We thank the two reviewers for their constructive comments and suggestions that helped improving the paper. We answer the two reviewers in detail below, in blue. We also want to point out some major changes we made in the paper during the review.

RC1: '[Comment on egusphere-2025-3320](#)', Anonymous Referee #2, 26 Sep 2025 [reply](#)

This study presents an intercomparison of formaldehyde (HCHO) vertical columns retrieved from FTIR, MAX-DOAS, and direct sun (DS) DOAS measurements at the Xianghe station in China. The MAX-DOAS, and direct sun (DS) are measured using the same instrument. The work aims to assess the consistency of these ground-based techniques and to some extent evaluate the performance of the current FRM4DOAS MAX-DOAS retrieval system. The main goals of the study are: (1) assess the quality of

Figure ans1: as Fig3 of the paper, but for FTIR vs MAX-DOAS MMF for Bremen over 2019-2022.

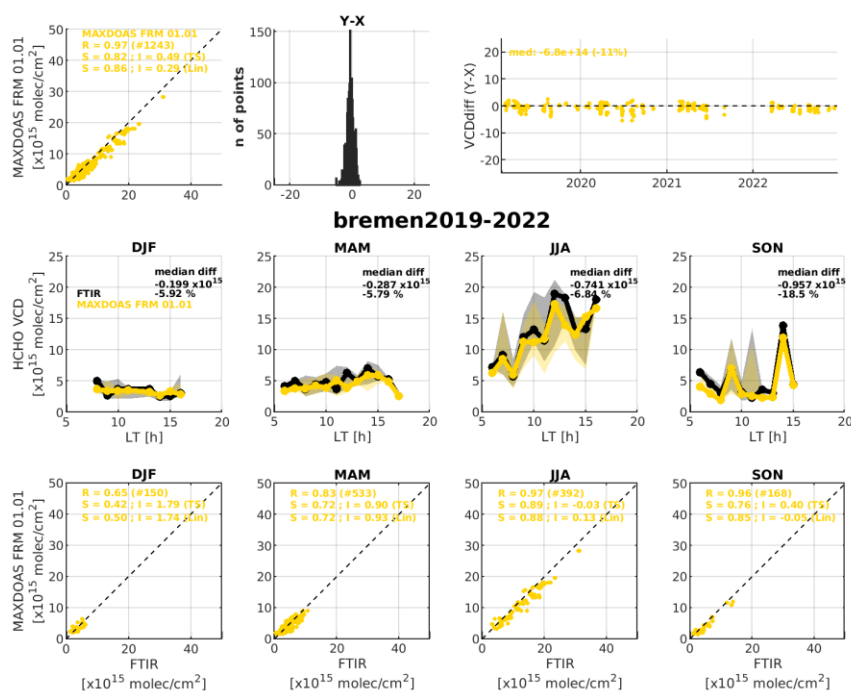
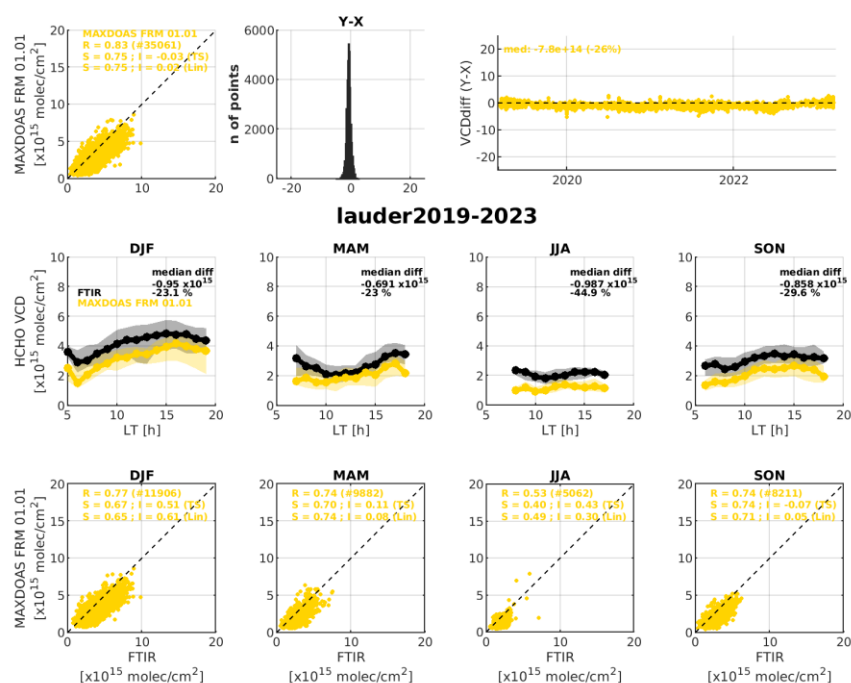
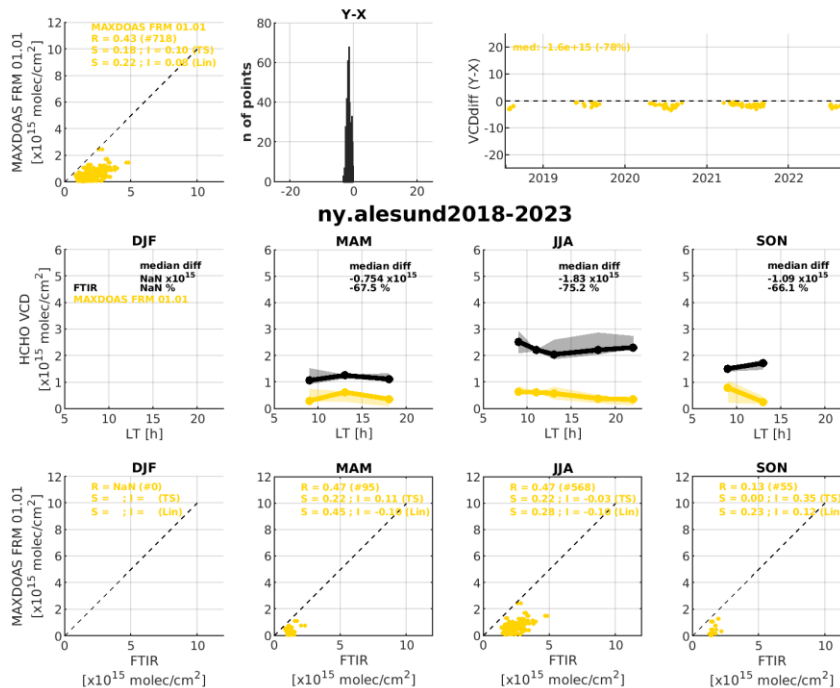
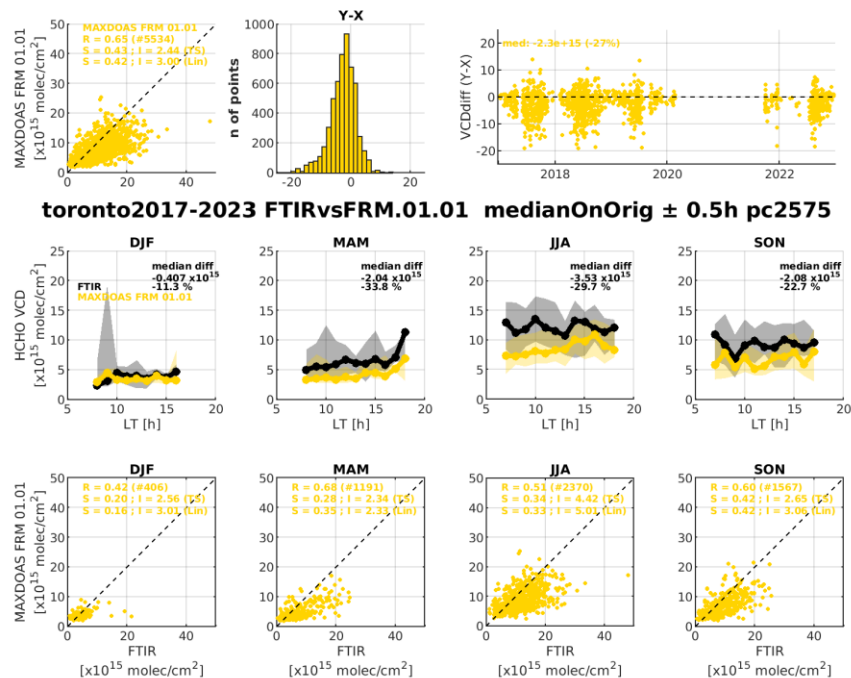
The manuscript provides valuable intercomparisons, especially because they incorporate the UV and IR Direct sun observations. However, the analysis is limited to a single site (Xianghe). The authors should discuss representativeness of suburban/urban conditions and how conclusions may differ in other regions, e.g., remote low HCHO levels and/or highly polluted regions. I do not recommend expanding the analysis to more sites but mentioning/reference how additional collocated sites (NDACC/FRM4DOAS) would strengthen the broader applicability of the findings.

We thank the reviewer for this comment. As mentioned in lines 549-554, there are other sites where a FRM4DOAS MAX-DOAS and an FTIR measure in parallel and we had performed preliminary comparisons at Bremen, Lauder, Toronto and Ny-Alesund, also finding MMF data being smaller than the FTIR VCD (see Figures ans1 to ans4 below for Bremen, Lauder, Ny-Alesund and Toronto). We commented this further in the conclusions, also stating that in some of these sites, a Pandora/PGN is also measuring

HCHO (in direct-sun and off-axis geometry) and that further comparisons are needed.

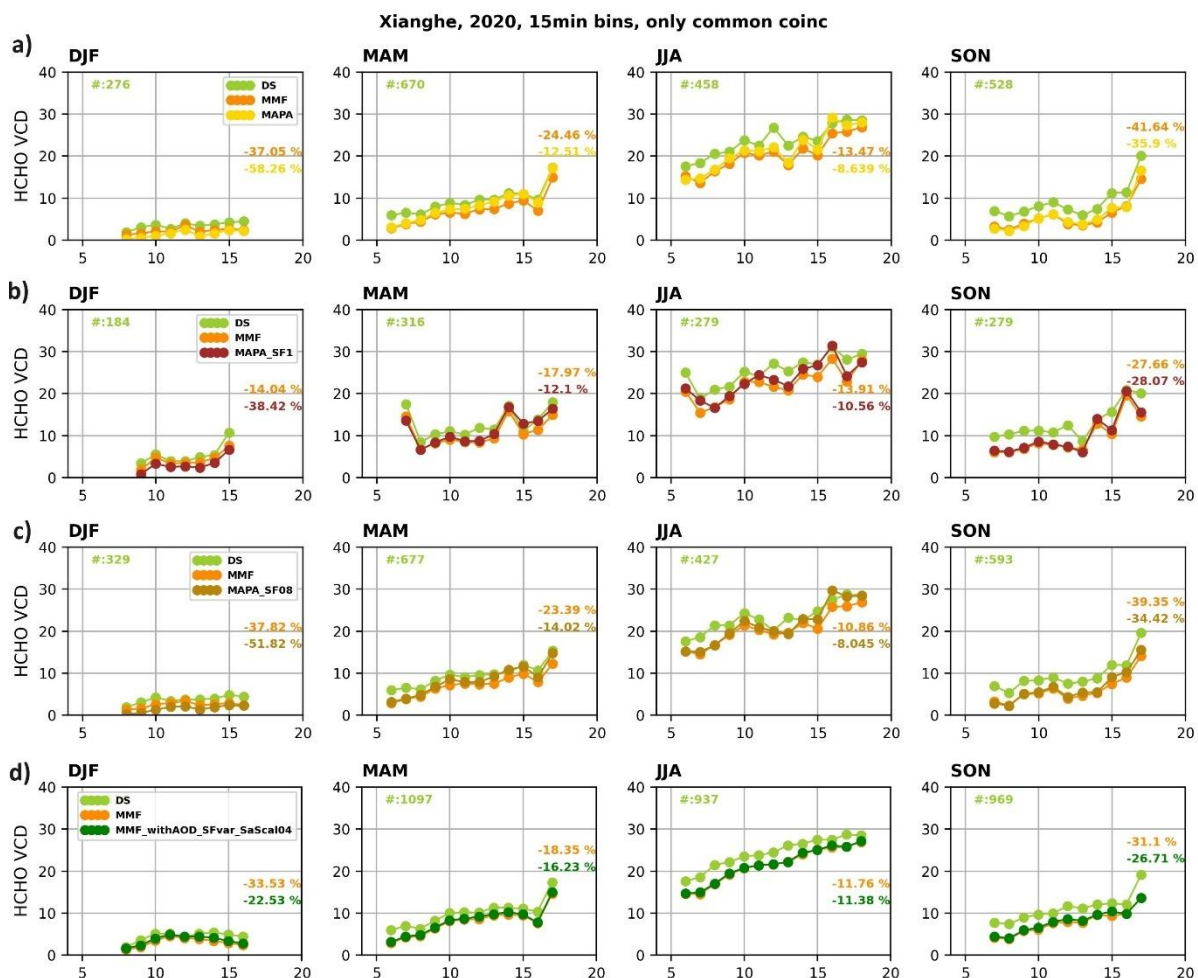
Also, the authors should more explicitly highlight how this study advances harmonization and validation efforts. For example, my understanding is that MMF does not consider a correction factor for O₄, is that correct?, while MAPA does. Have you seen the effect of using the same aerosol extinction profiles in both retrievals? Right now it is hard to see if aerosol is the cause of some of the discrepancies, what would authors recommend for FRM4DOAS given that MMF and MAPA results differ in too many cases as mentioned in the manuscript? An overall conclusion, suggestions, and guidance for improving the FRM4DOASr MAX-DOAS products is missing.

As a default run in FRM4DOAS, MMF is indeed not using any correction factor for O₄, while for MAPA three versions are run in parallel, one with a scaling factor $SF=0.8$, one with $SF=1$ and one where the SF is a fitted parameter, which is the version considered in the paper. We compared the different MAPA results, and we made an additional run of MMF forcing a multiplicative factor in the O₄ measured s_{cd} equal to the MAPA fitted SF . We show the results in Fig ans5, in the same style as the updated Fig 11 (see point 2) above). Results with the MAPA $SF=0.8$ are close to MAPA VAR results (the fitted SF is close to 0.8 in all the seasons (Fig ans6)) while results with $SF=1$ are strongly reducing the number of valid points, changing the statistics, especially in winter (and autumn). Results with the MMF variable SF are close to the original MMF ones, with some differences in winter (and minor in autumn). The impact of the different data selection (sampling) in winter (and autumn) is clear.

Xianghe 2018-2021, MMF

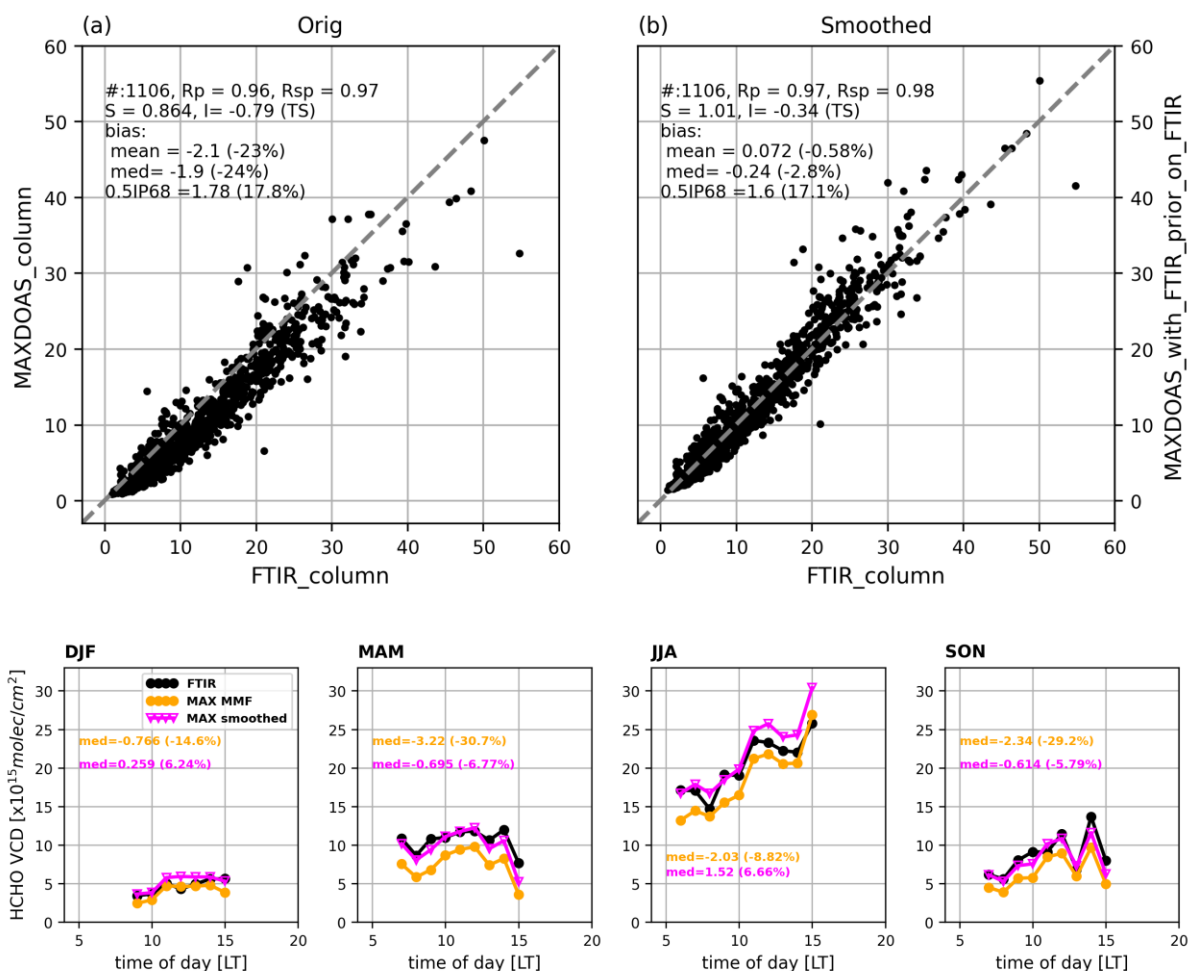
When harmonization (Rodgers & Connor approach) is applied, mean biases improve but regression slopes/intercepts sometimes degrade. This needs clearer explanation to avoid confusion about whether retrievals are actually improved and whether the smoothing process is actually needed, especially given the complexity of all the transformation variables.

As discussed above, we have revised the smoothing step and we realized that our current choice of regridding options (to bring the substituted MAXDOAS profile on the FTIR grid) was introducing a seasonality. We were using the FTIR prior above 4km, but as the FTIR prior is fixed, it was introducing some biases by leading to larger values than the FTIR retrieved in winter and smaller values in summer (see previous Fig A5 now in Fig 6). We clarified this step in the manuscript, adding some explanations between eq 5 and eq 6, and we revised the choice to use the FTIR retrieved profile itself for the extension above 4km. This solved the worse regression results after the harmonization. We also extended the MAXDOAS to FTIR comparisons to the whole 2018-2021 period, resulting in this new Fig 8 and new Fig9:

The substitution and smoothing are reducing the bias in all the seasons now. In summer and winter, the smoothed MAX VCD is now slightly larger than the FTIR itself, but all the differences are now around $\pm 6\%$, which is the median difference for the FTIR to DS UV comparisons.

Figure ans7: HCHO DS UV AKs difference with respect to the annual mean as a function of SZA, for different months of the year.

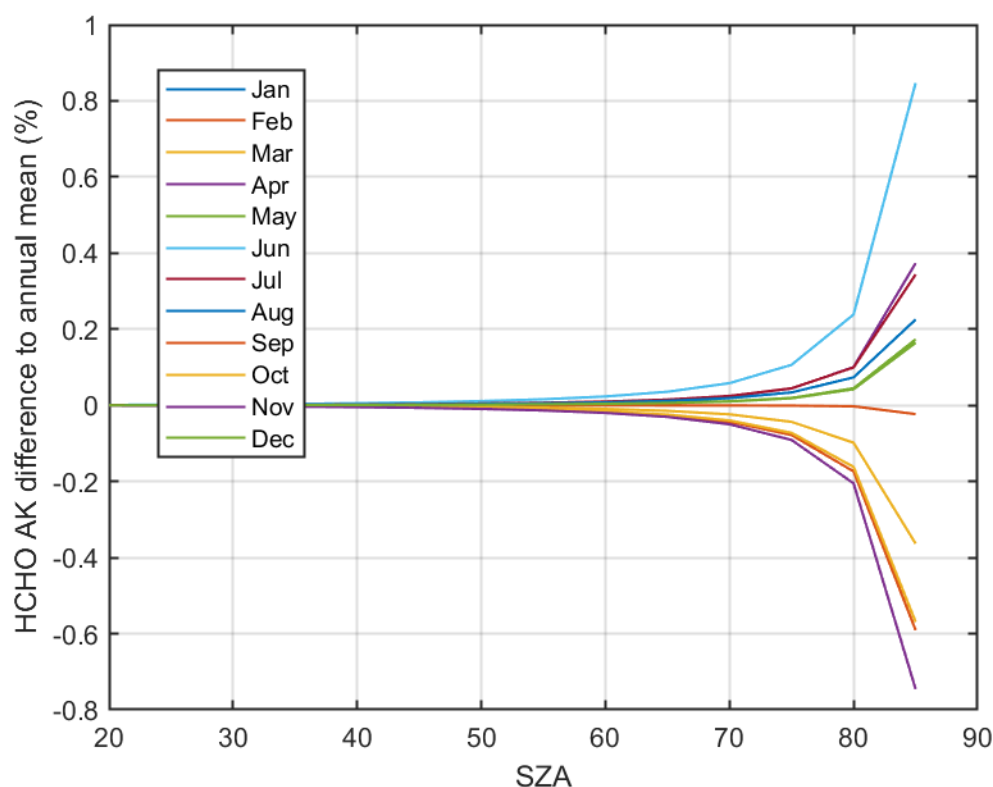
Figure 2: How is the direct-sun averaging kernel in panel (b) estimated? Is it the total column AK? If so, please state this explicitly, and consider also including the FTIR total column AK for comparison.

The total column averaging kernels for UV direct-sun geometry (and corresponding airmass factors) were estimated using a ray-tracing model accounting for earth sphericity and the temperature dependence of the HCHO absorption cross sections. We use the formulation developed by Eskes and Boersma (2003) for optically thin absorbers, which relates the averaging kernel to the airmass factor calculation. The HCHO a-priori profile is based on monthly averaged CAMS model simulations for the month of June. Tests using a range of other profiles covering a full year show negligible dependency (<1%, see Fig ans7 below). In Figure 2b) it is indeed a total AK that is shown (please note we have added more curves up to 85°SZA in panel b)). We added a sentence in the figure caption. The total AK comparison for DS, FTIR and MAX-DOAS is presented in Fig7, so we decided not to add it in Fig2 to keep it simpler.

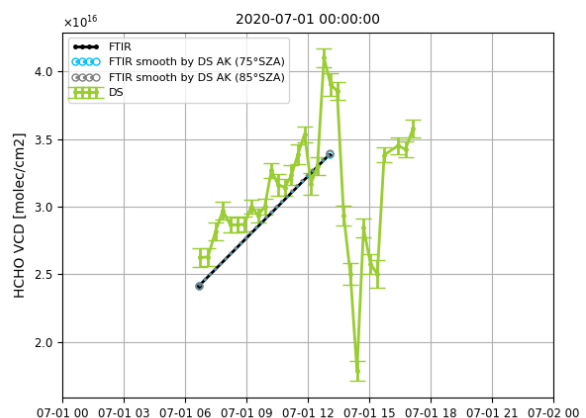
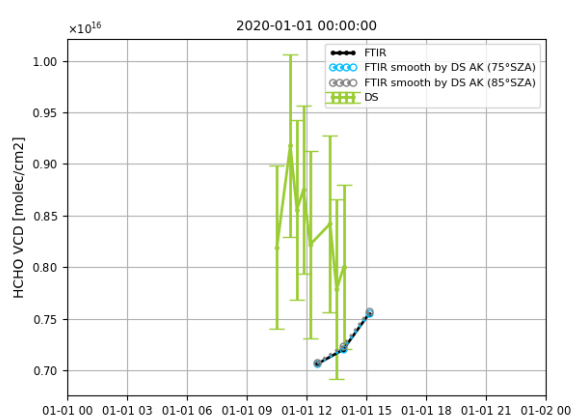
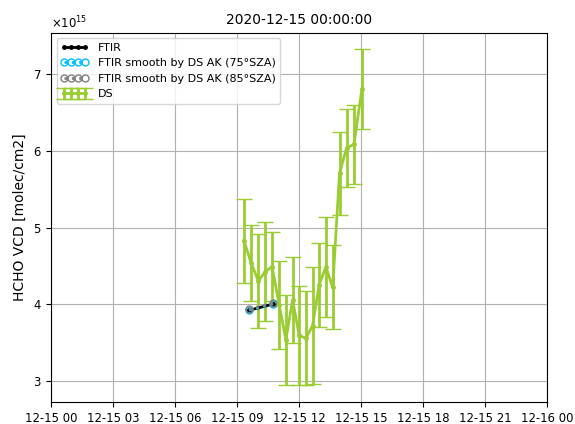
Section 3.1.1: It appears averaging kernels are not applied in the FTIR vs MAX-DOAS DS comparison. Please confirm if this is correct, and if so, justify why it is not necessary to account for the AK differences.

Indeed, DS AK are not applied to the FTIR profile in Fig 3, Sect 3.1.1 as the DS UV AK are close to 1 compared to FTIR ones, see Fig7 and see the revised Fig2b) where we have added a few more curves for the DS AK for more intermediate SZA values. Compared to the AK of the other instruments, the DS UV AK are only deviating significantly from 1 for SZA around 75° and above (increasing the HCHO profile below 2km height and decreasing the profiles above), and we don't have many such conditions in the FTIR measurements. We have made a test for a few days applying the DS UV AK profile for SZA= 75° or 85° to FTIR profile, with changes on FTIR VCD smaller than 0.5%. We added this info in lines 416-422.
